Release Fractions in Non-LOCA Accidents in Draft Regulatory Guide 1.183 DG-1199

N. C. Andrews, R. O. Gauntt
Sandia National Laboratories
P.O. Box 5800, MS 0748

Figure 1. Predicted Release Fraction for Kr-85 (Long-Lived) Isotope as a Function of Burnup Illustrating Peak Release Occurs Near EOL (Figure 2.5 in PNNL-18212 rev. 1)

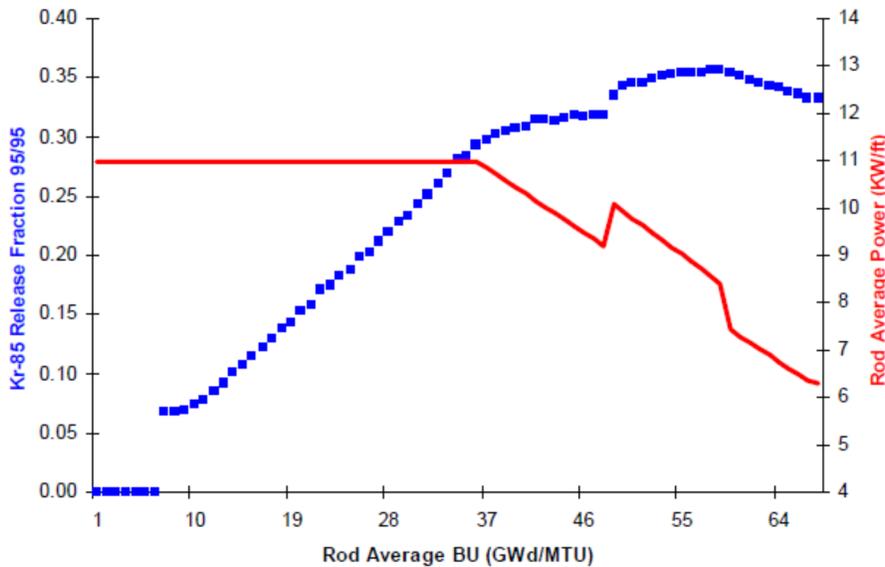
The higher values of Kr-85 release in DG-1199 can be attributed to higher burnups that needed to be considered in order to create a bounding case for the regulatory guide. It can be seen that at high burnup the predicted release fraction for Kr-85 increases to a peak near a rod-average burnup 55 MWd/kgHM. This can be seen in Figure 1.

Tying alkali metal (and Cs) release directly to Kr-85 release leads the release of cesium to be extremely high relative to other known measurements of Cs release behavior from experiments. Moving from DG-1081 to DG-1199, the alkali metal release fraction increased by nearly a factor of four, from 0.12 to 0.50. It is believed that an increase this large without a justification that is based on cesium-specific data does not reflect current understanding and could be excessively conservative.

It is recommended that in lieu of scaling the cesium release with Kr-85 a physics-based or empirical data-based chemical transport model for cesium release be used. Should the cesium release be calculated based on the release of a noble gas, it is recommended that the cesium release be based on that of xenon and not krypton. Xenon is included in the “other noble gases” listed in Tables 1, 2 and 3.

Figure 2: Burnup-Dependent Transient FGR Correlations. Open symbols indicate non-failed, solid symbols indicate cladding failure. (Clifford, 2015)

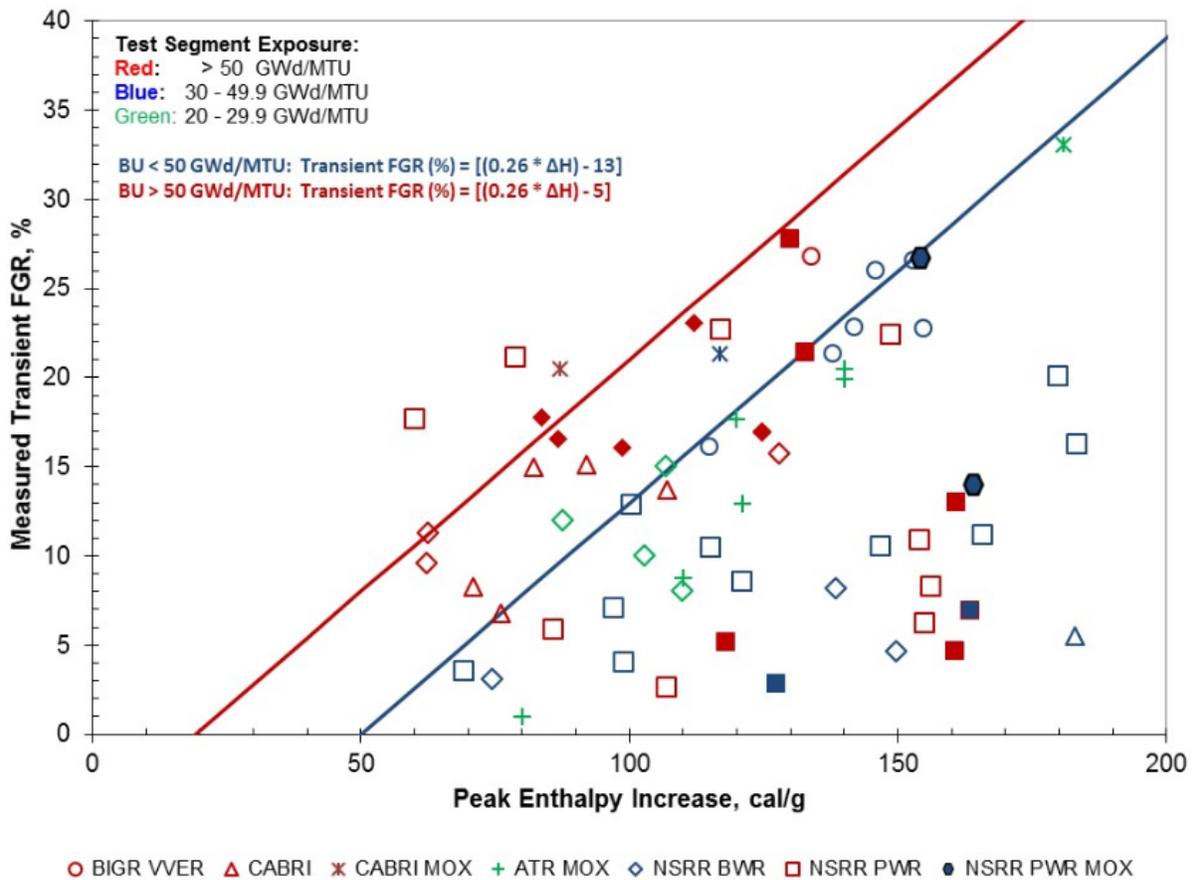
New regulatory guidance within Clifford (2015) indicates that a revision of the fragmentation-induced fission gas release fractions found within Table 4 of DG-1199 requires an update. (See Table 2 of this note.) This update is only pertinent to reactivity insertion accidents, and hence only applies to Table 4 of the document. Within Clifford (2015) new experimental data is presented and proposed changes to the fragmentation-induced factors are made. It is recommended that these changes be implemented within DG-1199. Specifically, it is recommended that the “Kr-85” and “Other Noble Gas” entries of Table 4 in DG-1199 be

These two separate correlations follow the experimental data closely, as can be seen in Figure 2, where both are applied against multiple data sets for different reactor and fuel types.

Kr-85: $((0.38) + (0.0022 * \Delta H)) \rightarrow ((0.38) + (0.0026 * \Delta H - 0.05))$
 Other Noble Gases: $((0.084) + (0.00073 * \Delta H)) \rightarrow ((0.084) + (0.0026 * \Delta H - 0.05))$
 Alkali Metals: $((0.50) + (0.0031 * \Delta H)) \rightarrow ((0.084) + (0.0037 * \Delta H - 0.07))$

Kr-85: $((0.38) + (0.0022 * \Delta H)) \rightarrow ((0.38) + (0.0026 * \Delta H - 0.13))$
 Other Noble Gases: $((0.084) + (0.00073 * \Delta H)) \rightarrow ((0.084) + (0.0026 * \Delta H - 0.13))$
 Alkali Metals: $((0.50) + (0.0031 * \Delta H)) \rightarrow ((0.50) + (0.0037 * \Delta H - 0.18))$
